SUBJECT: Transmittal of Revised Westinghouse Proprietary and Non-Proprietary Responses to U.S. Nuclear Regulatory Commission Requests for Additional for the AP1000 Application for Design Certification

Westinghouse Revised Non-Proprietary Responses
to US Nuclear Regulatory Commission
Requests for Additional Information
dated March 17, 2003

AP1000 DESIGN CERTIFICATION REVIEW

Figure 440.091-16 ADS Stage 4A Vapor Velocity at Offtake Pipe
(DCD Long-term Cooling Case)

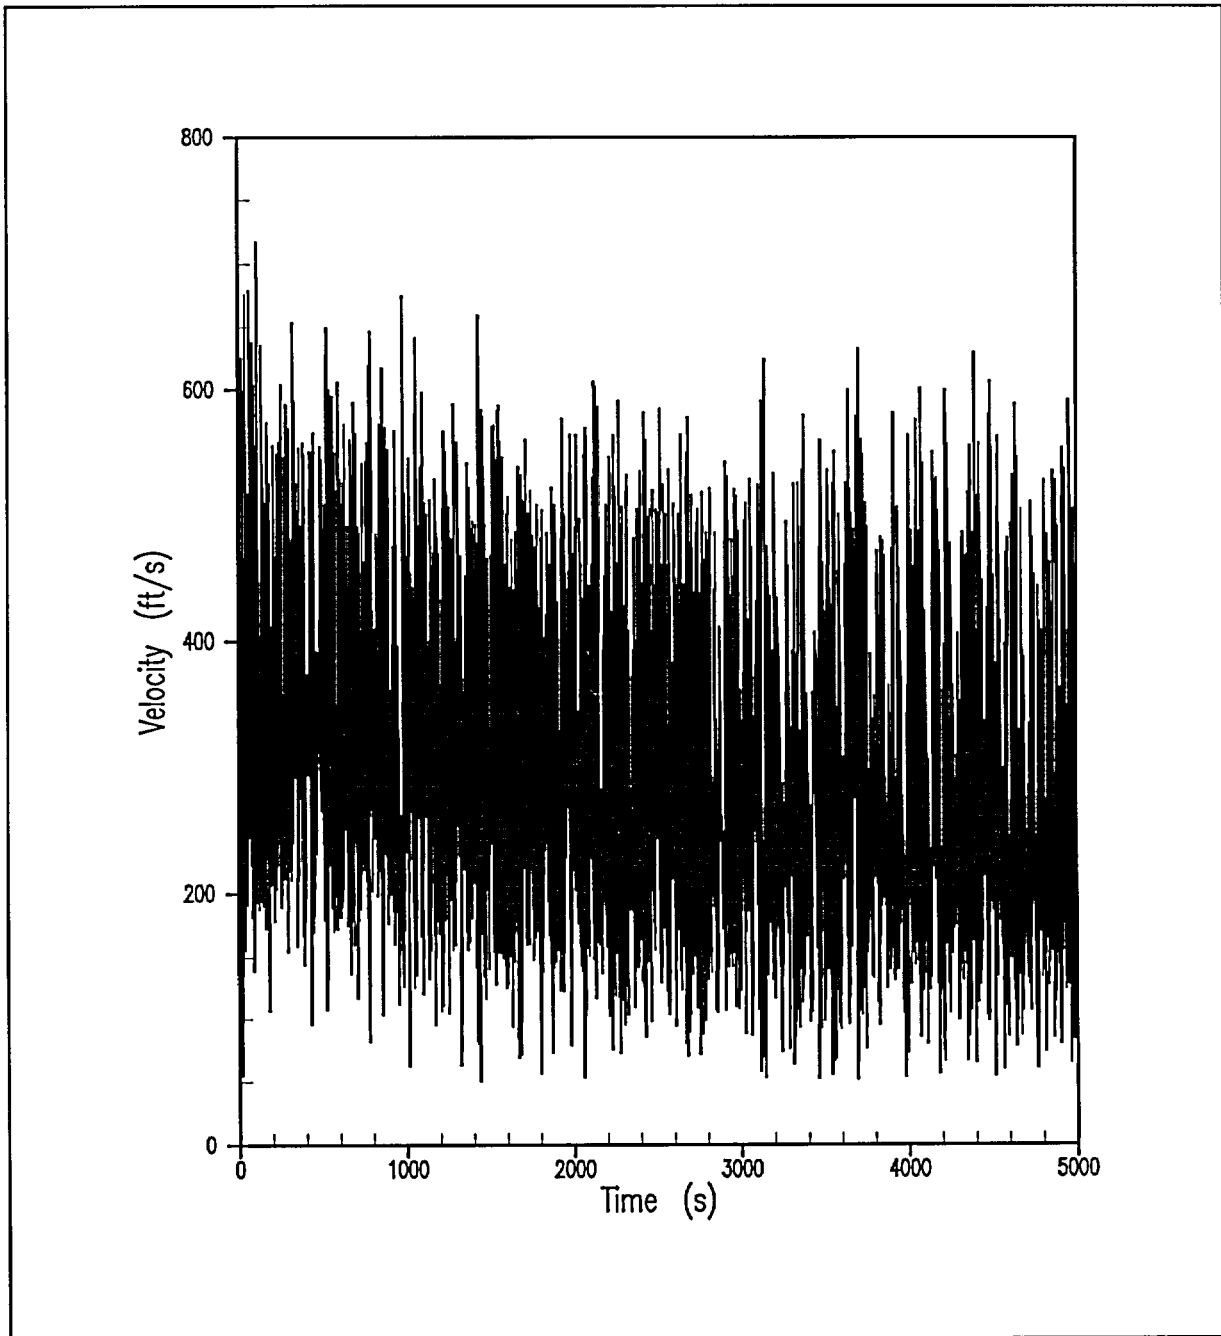
Will that steam velocity be able to entrain and remove liquid from the core? (Note, it is not feasible to draw this conclusion from the information in the code applicability report without extensive calculations.)

The question is concerned with the removal of liquid from the AP1000 core / upper plenum at a minimum steam velocity condition. The concern is whether there exists sufficient liquid carryover out the ADS-4 valves post-LOCA to prevent the potential for boron precipitation in the reactor vessel. As was demonstrated for the AP600, liquid carryover from the ADS-4 valves prevents the reactor vessel boron concentration from approaching the concentration where boron would precipitate. A boron concentration of approximately 35,000 ppm at 240F is necessary to cause boron to precipitate out of solution. Bounding calculations performed for the AP1000 have determined that the maximum post-LOCA boron concentration calculated for the limiting long-term cooling analysis cases presented in the DCD is 5500 ppm. This represents a large margin to the value where boron precipitation could be a concern.

A set of figures is provided presenting the results obtained from the WCOBRA/TRAC run for this scenario. Liquid flow through the ADS-4 flow paths is adequate to ensure that boron will not concentrate in the core. As seen on Figure 440.091-15, the average steam velocity through the ADS-4 Stage 4A flow path in the offtake pipe from the hot legs is 95 ft/sec, while in the DCD case the average steam velocity at the same location is almost 300 ft/sec (Figure 440.091-16). Overall, the figures show that amount of liquid carryover is increased for this scenario. As seen in comparison to the DEDVI long-term cooling analysis results presented in the DCD, the vessel injection is greater, and reactor vessel level is higher throughout the transient. This is primarily due to the faster RCS depressurization resulting from all four ADS-4 valves opening. Even though the vapor velocity in the ADS-4 flow paths is reduced, the core remains covered and cooled, and the liquid carry-over out the ADS-4 is increased (when compared to the cases presented in the DCD). Thus boron precipitation in the reactor vessel will not be a concern for the postulated scenario raised in this RAI.

Figure 440.091-1-1 Sump Injection Phase – ADS4 Pipe (Vertical)
Vertical Flow Regime Map (Taitel-Dukler)

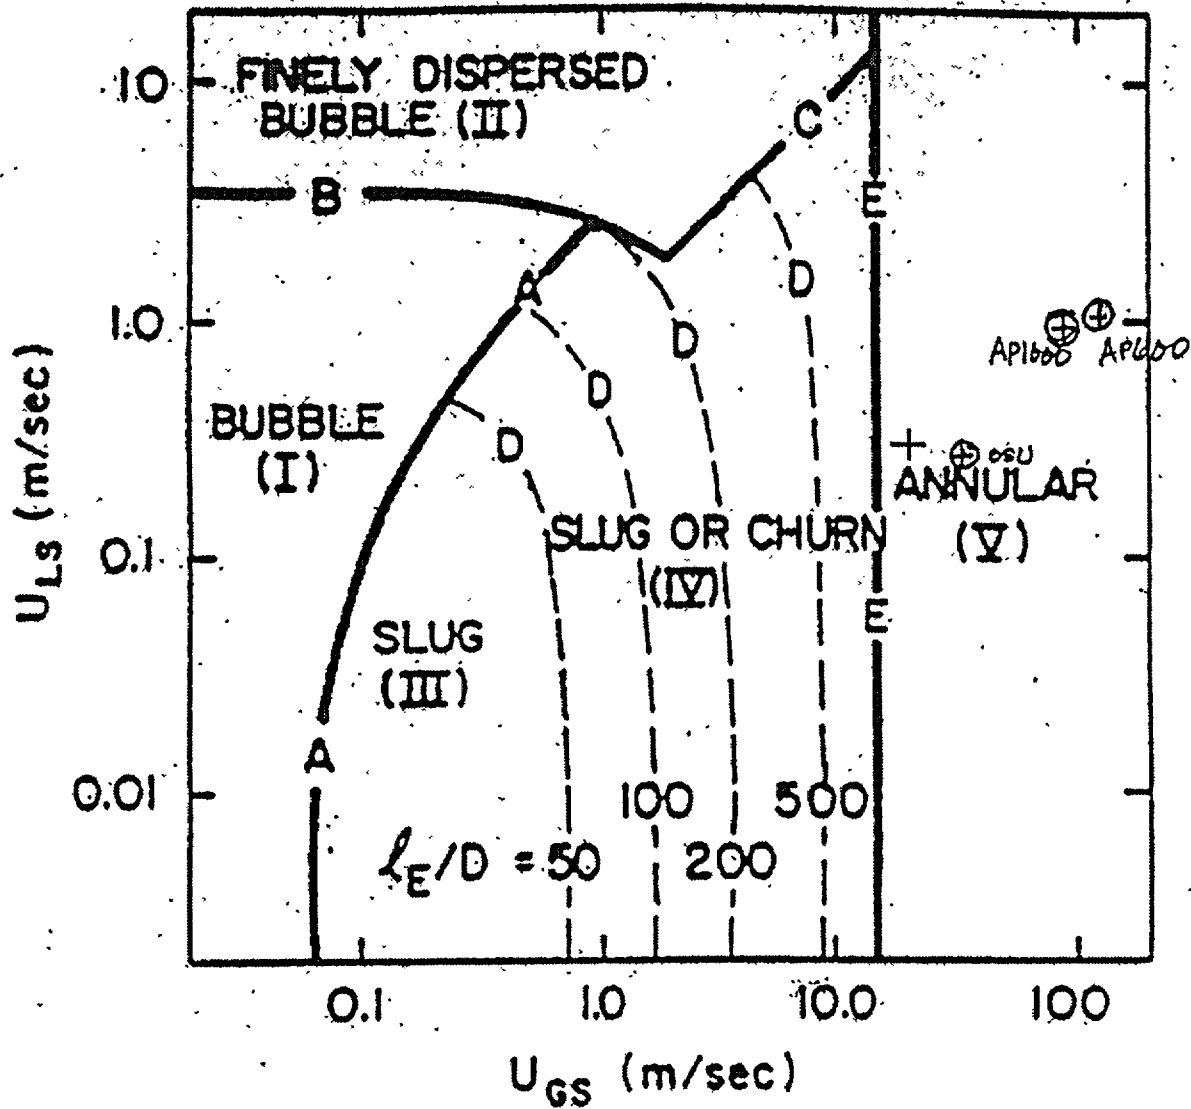
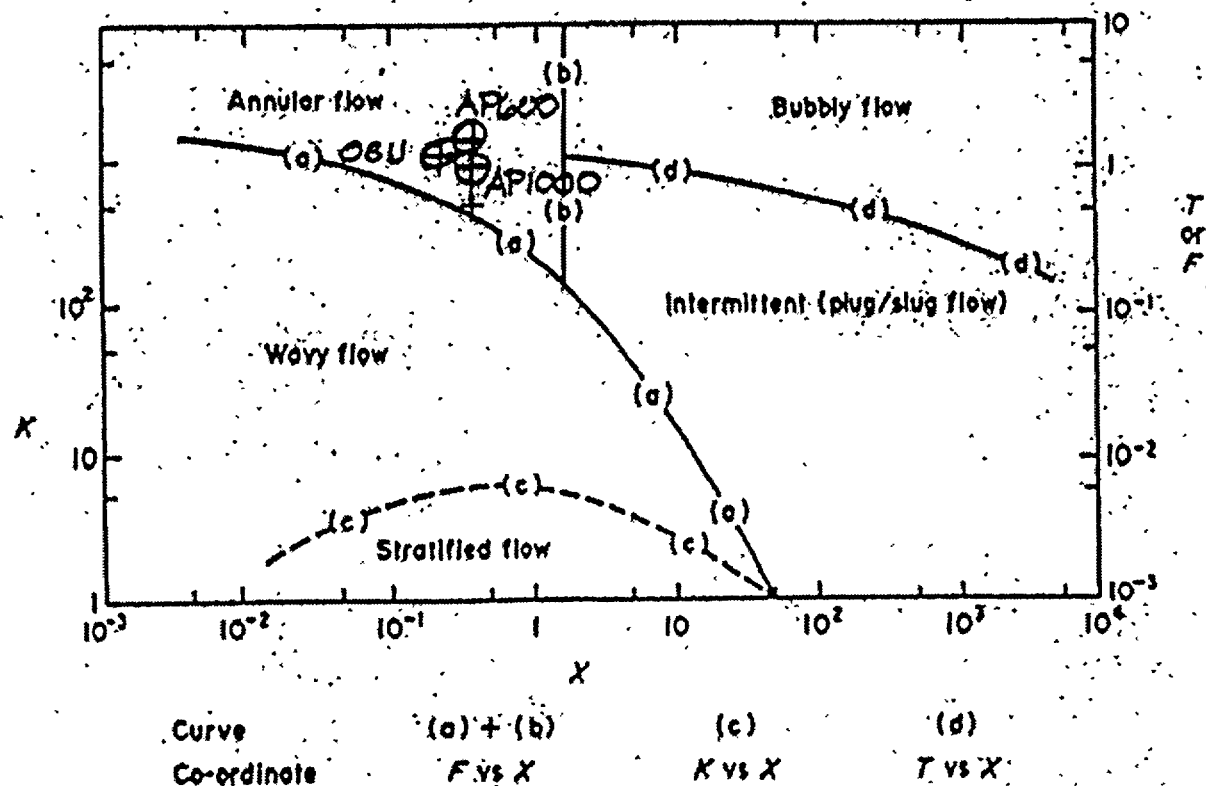
The response did not address the question i.e. given the differences in the physical dimensions between AP600 and AP1000 is WCOBRA/TRAC qualified to calculate liquid entrainment in the ADS-4 under conservative long-term cooling (LTC) conditions. The response does not allow a quantification of the liquid flow.

Please address the following: (1) the qualification of WCOBRA/TRAC to calculate liquid entrainment in the automatic depressurization system stage 4 (ADS-4) under conservative LTC conditions for the physical configuration of the AP1000, (i.e. slug flow in AP600 vs droplet entrainment in AP1000, (2) is 95 ft/sec above the entrainment velocity for the AP1000 configuration? And (3) quantify the liquid flow through ADS-4 for the conditions discussed in the December 2, 2002 response.

WCOBRA/TRAC has been validated for the calculation of advanced plant long-term cooling phenomena against APEX facility data in WCAP-14776, Rev. 4. The attached figures 440.091-1-1 and 440.091-1-2 show that the validation was performed for ADS-4 two-phase flow data in the annular flow regime, and that flow regime is present in the ADS-4 piping for the scenario requested in this RAI. The uncircled "+" symbol on each figure shows the flow regime from the run performed for this RAI response. Annular flow is predicted to occur in both the vertical and horizontal piping segments of the ADS-4 piping during the RAI-440.091 scenario, as it is in the AP1000 DCD Section 15.6.5.4C DEDVI break analysis. Since annular flow is the flow regime present in the APEX test ADS-4 piping and also in both of these AP1000 simulations, in each case the velocity at the start of sump injection is adequate to move liquid through the vertical and horizontal ADS-4 piping lengths until discharge into containment. The AP1000 long-term cooling ADS-4 flow path flow regime is concluded to correspond phenomenologically to the APEX test condition with or without the postulated single active failure of an ADS-4 valve.

FIGURE 440.097 R1-1

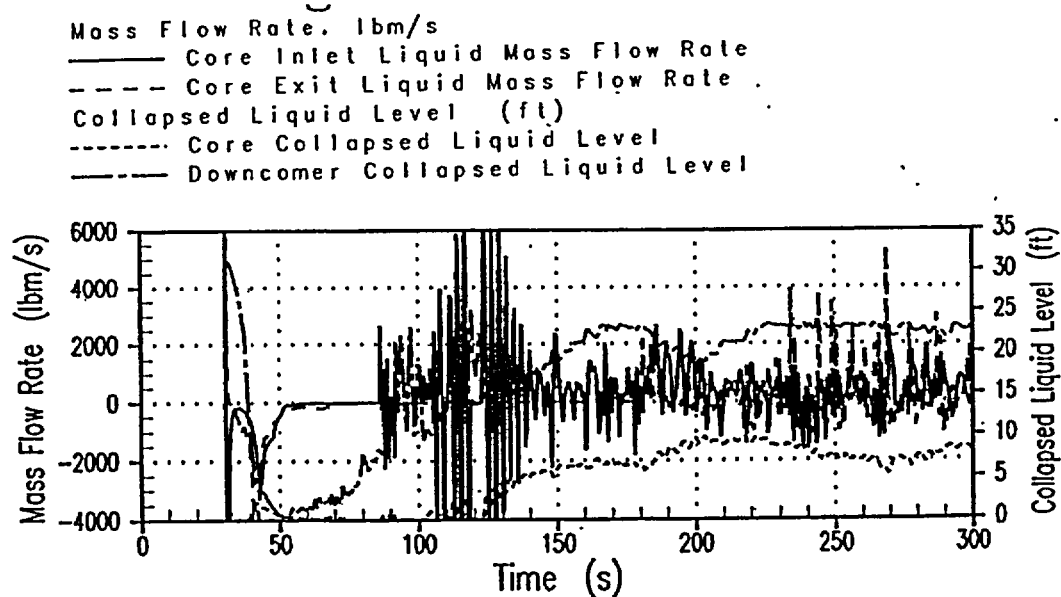
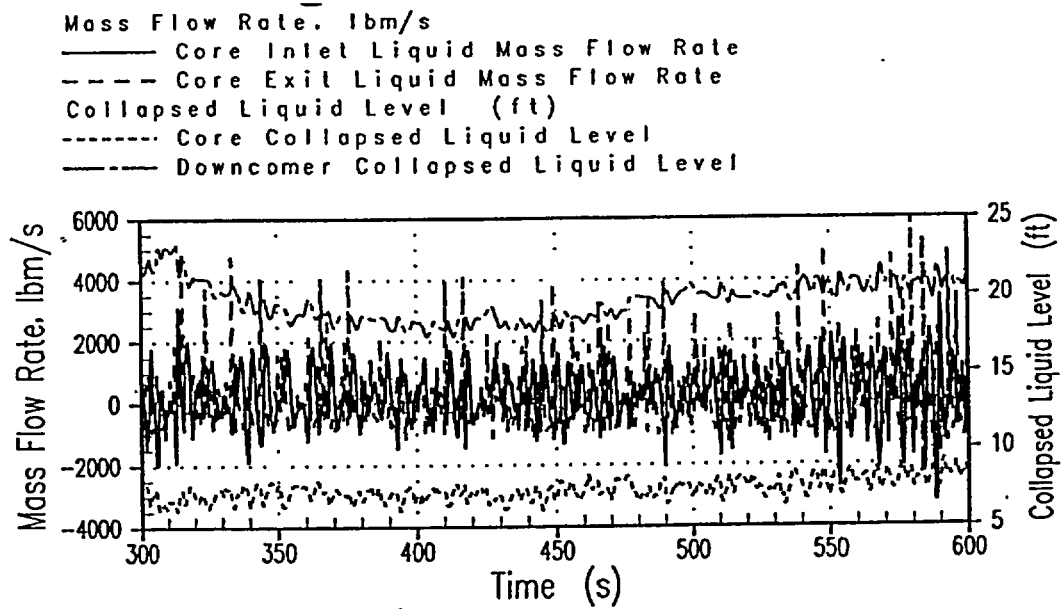
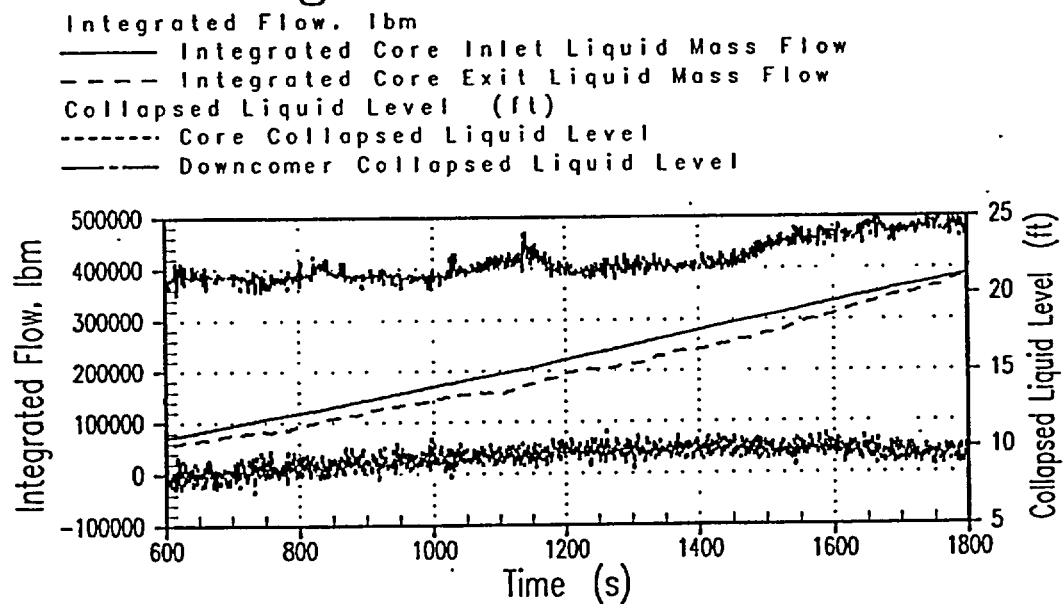
- A. Please address limitations 4c and 4d, i.e., maximum local oxidation and submit the results for staff review.
- B. The integrals of the flows shown in Figures 15.6.5A-5 and -6 do not match the contents of the accumulators and the core makeup tanks (CMTs), respectively, shown in Table 2.1-1 of WCAP-15612. Please comment on the flows shown in these figures and indicate in a single graph the core coolant inflow, outflow, downcomer level and core level vs time from the initiation of the transient to the initiation of in-containment refueling water storage tank (IRWST) injection (a similar graph was prepared for AP600).

- D. It is stated (pg. 15.6-46a) that "Figure 15.6.5A-12 presents the collapsed liquid levels in the core referenced to the bottom elevation of the active fuel (solid line) and downcomer (dashed line) referenced to the bottom of the reactor vessel". How is it possible that these levels have the same value at about 20 seconds?

The graph requested is provided in the three figures attached. Three figures are used to show the requested flows and levels in different time segments to provide a reasonable resolution. The actuation of ADS-4 flow and IRWST injection is not modeled in the WCOBRA/TRAC run, but would occur due to a LO/LO level in the intact loop CMT between 1700-1800 seconds. The collapsed liquid level in the core is referenced to the bottom elevation of the active fuel, and the collapsed liquid level in the downcomer is referenced to the bottom of the reactor vessel. The Figures show that CMT injection is adequate to maintain mass inventory in the core and downcomer once the accumulator has emptied.

D. The statement in the DCD about Figure 15.6.5A-12 is correct. The first figure from Part B illustrates the reason why the core and downcomer levels are approximately the same at 20 seconds transient time (50 seconds on Figure 440.097-1-1). At this time the downcomer is highly voided because its initial inventory has been discharged through the break and the accumulator injection is bypassing to the break. The source of the liquid in the core at this time is not flow from the downcomer but rather liquid that has entered the top of the core from the upper plenum as the upper head drains (shown as negative flow at the top of the core prior to 50 seconds on Figure 440.097-1) that proceeds through the core toward the lower plenum and the break location.

Figure 1. Branch line quality for liquid level at main pipe midplane for ATLATS and AP1000.

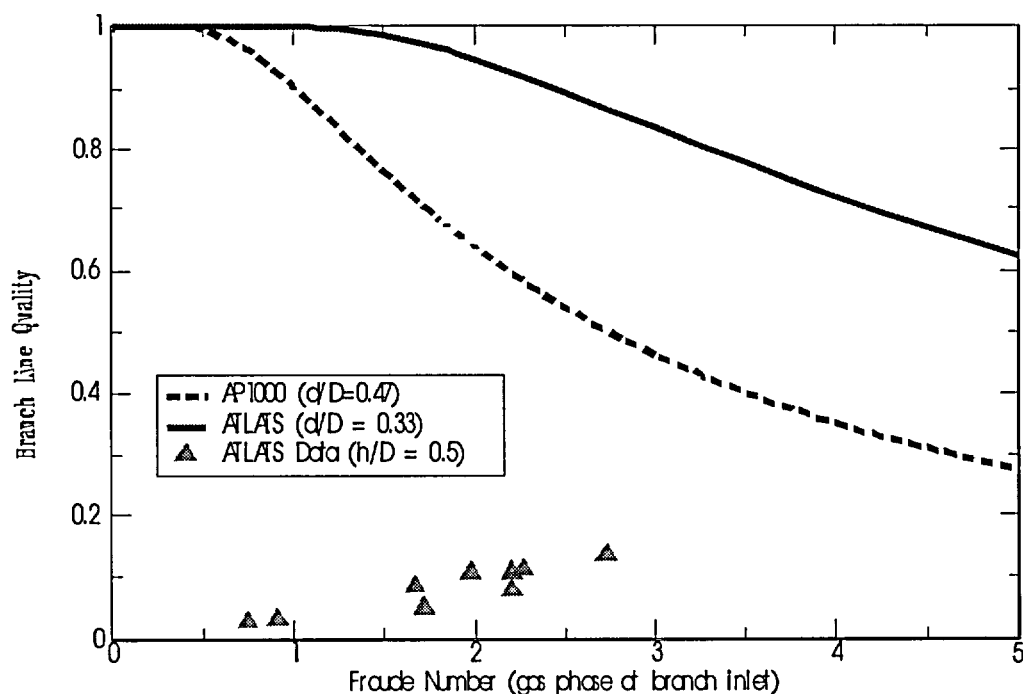
The comparison suggests that the model and coefficients of Equations (1) and (2) and Table 1, grossly overpredict the ADS-4 quality for conditions expected in AP1000. Please provide suitable justification for Equations (1) and (2) and their coefficients for the large d/D ratios in the AP1000 design. Provide justification that the phase separation equations used in the WCOBRA/TRAC-AP code are appropriate for AP1000 ADS-4 analysis in light of these data.

With respect to addressing the data associated with the ATLATS separate effects test facility, Westinghouse does not have detailed information regarding these tests (i.e facility layout, boundary conditions, test procedures, scaling analysis, etc.) and therefore these tests have not been analyzed by Westinghouse. Based on our understanding of the ATLATS test program, a possible explanation for the different behavior displayed in ATLATS (relative to the stratified flow type entrainment behavior expected in AP1000 and as seen in other test facilities) is that the ATLATS test facility is producing a different flow regime that could be attributed to its non-prototypic or incomplete simulation of the actual AP1000 configuration. The amount of effort necessary for Westinghouse to perform a detailed assessment of the ATLATS tests program, including the detailed evaluation of its design, scaling analysis, boundary conditions, test procedures, and test results that would otherwise be necessary for Westinghouse to consider the results of this test program are not warranted. Westinghouse believes that the staff can make the necessary safety determination for the AP1000 without a detailed assessment by Westinghouse of the ATLATS facility test results. We believe that WCAP-15833 Revision 1 provides the necessary information for the staff to determine the importance of upper plenum and hot leg entrainment and their effect on AP1000 plant safety.
